UNIVERSITY OF SOUTH CAROLINA

AMENDMENT TWO TO SOLICITATION

SUBJECT: SOLICITATION NUMBER: USC-IFB-2956-JB

DESCRIPTION: USC Strom Thurmond Wellness & Fitness Center Signage & Graphics

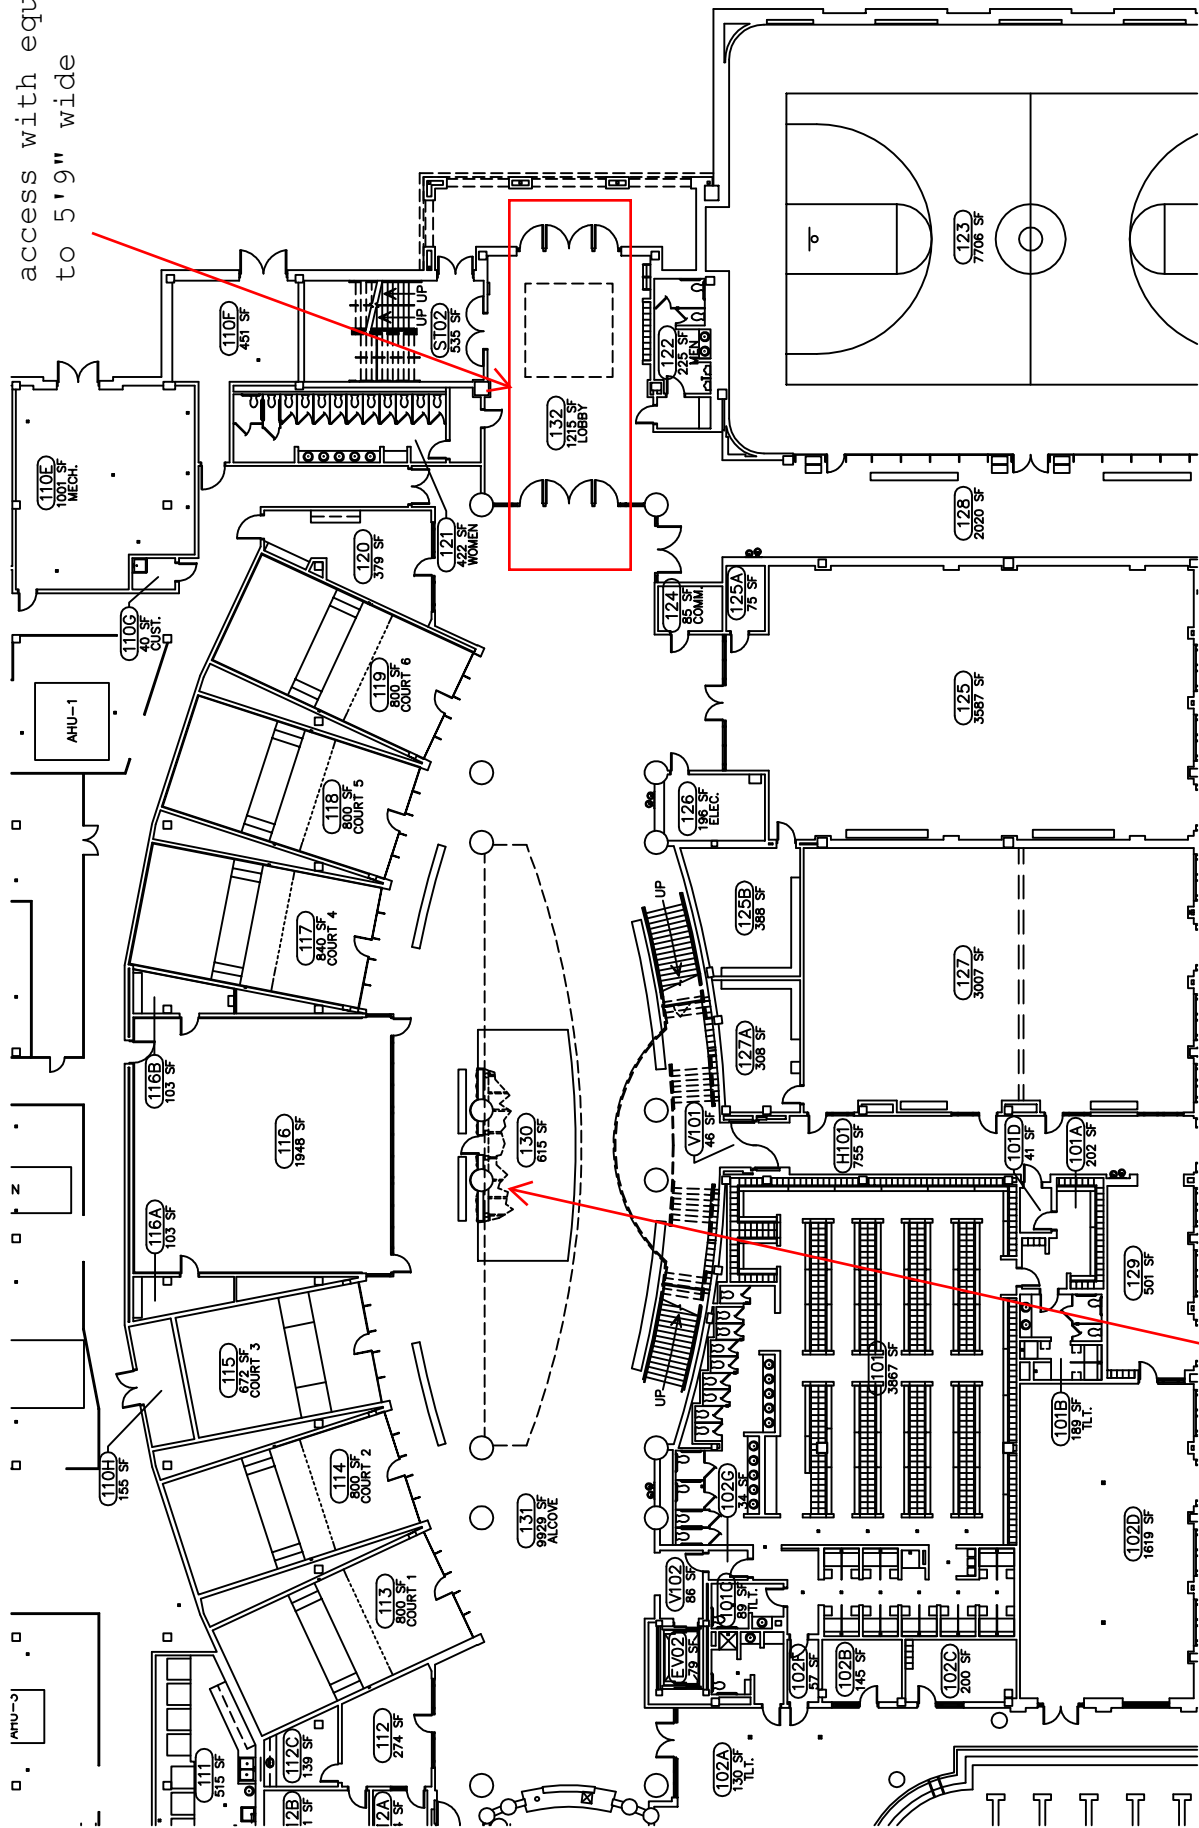
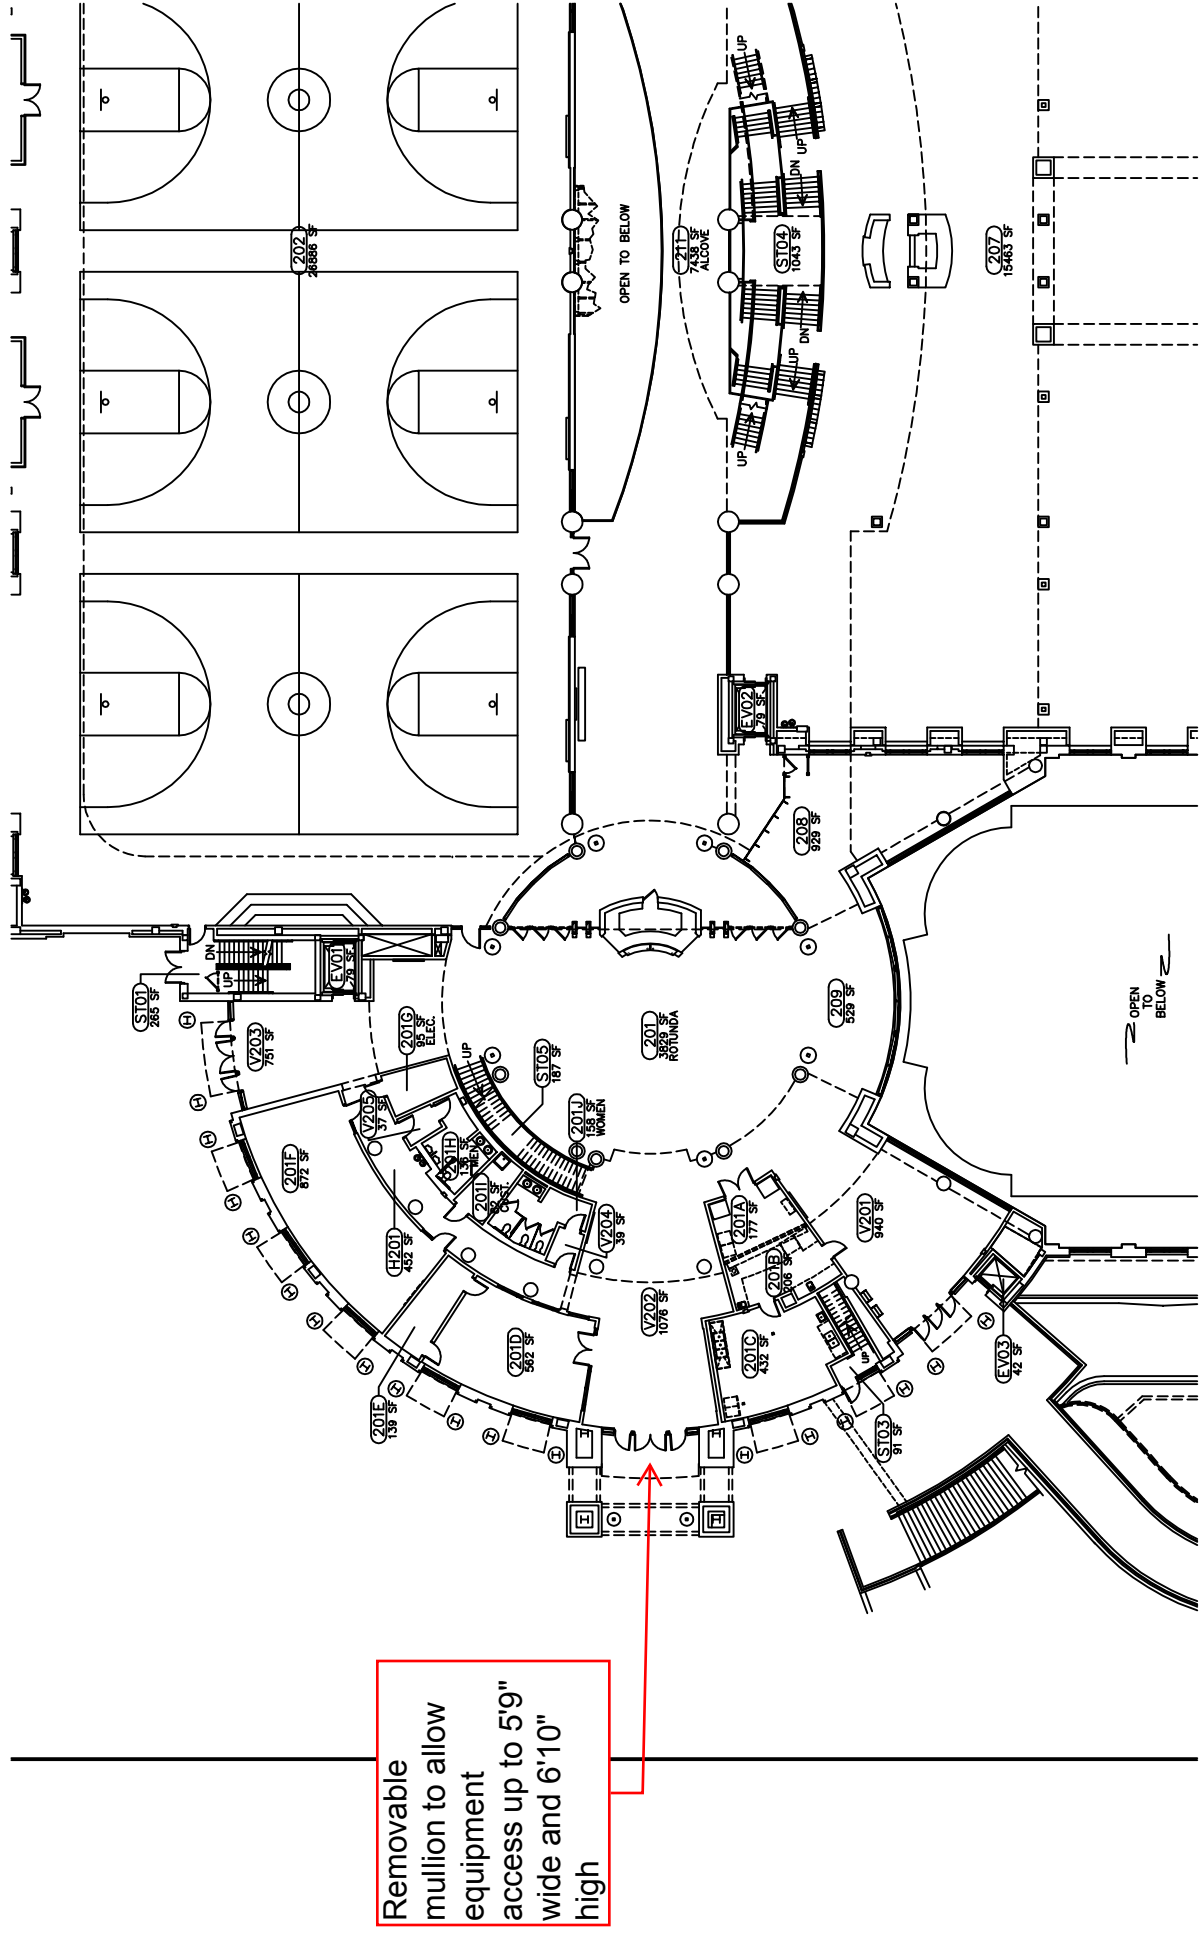
Q10. – are we allowed to use a jeni boom for the soffit graphics in the routunda? **There is a removable mullion at the front entry doors that will allow equipment up to 5'9" wide x 6'10" tall to enter. Floor must be protected from wheel damage. Weight and wheel base information will have to be supplied and approved prior to equipment use.**

Q16. Could you please let me know or find out if there is a service entrance to the building. We may have to use a larger than normal scissor lift for the large walls beside the rock climbing structure. The size lift we would need is 5' 9" wide so it won't go thru standard doors. If we can't use a scissor lift scaffolding would probably need to be used. **There is a removable mullion at the front entry doors that will allow equipment up to 5'9" wide x 6'10" tall to enter. Floor must be protected from wheel damage. Weight and wheel base information will have to be supplied and approved prior to equipment use.**

Removable mullions - can access with equipment up to 5'9" wide

Rock Climbing Wall - open to main floor above

1 F3 Corridor Graphics - Front Elevation
SCALE: 3/8" = 1'

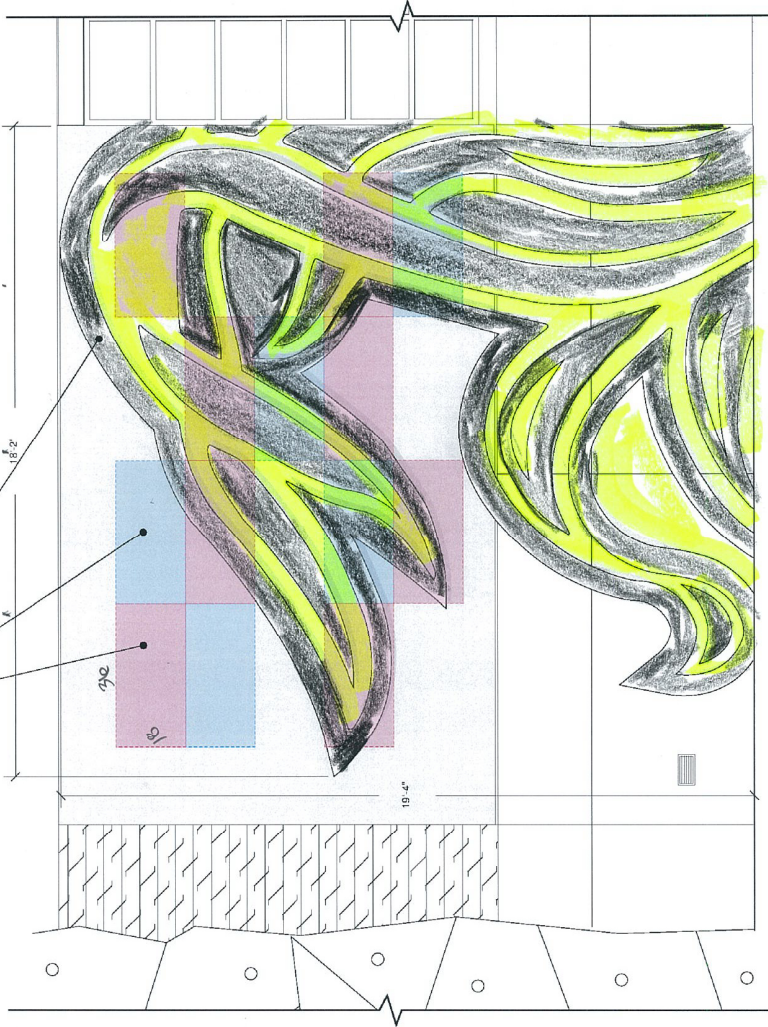
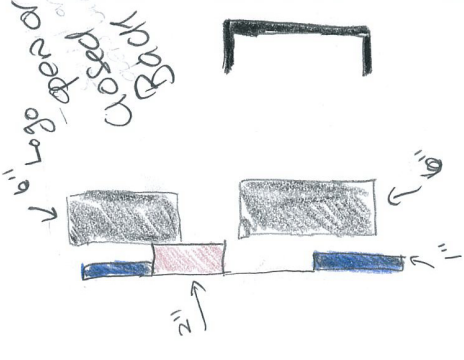
Q13. – On page 5, the corridor graphics I am not following the design fabrication installation process. Are you saying you have 1" and 2" deep aluminum boxes with a 6" deep channel logo mounted on top of the boxes. Are you saying that the gamecock tail covers the images on the 1" x 2" boxes? How do you intend to secure the 6" logo to boxes and wall? Can you provide more information? **See Attachment 3. See my attached image. Is the yellow in my attached image see through and the black solid? The fabricated feathers are mounted direct to the existing block wall. The 2x4 panels are mounted on top of the feathers. The fabricated feathers serve as a background for the graphic**

panels. Installation detailing/engineering is part of the required scope. Yes, what you have as black is fabricated, what you show as yellow is open space/void.
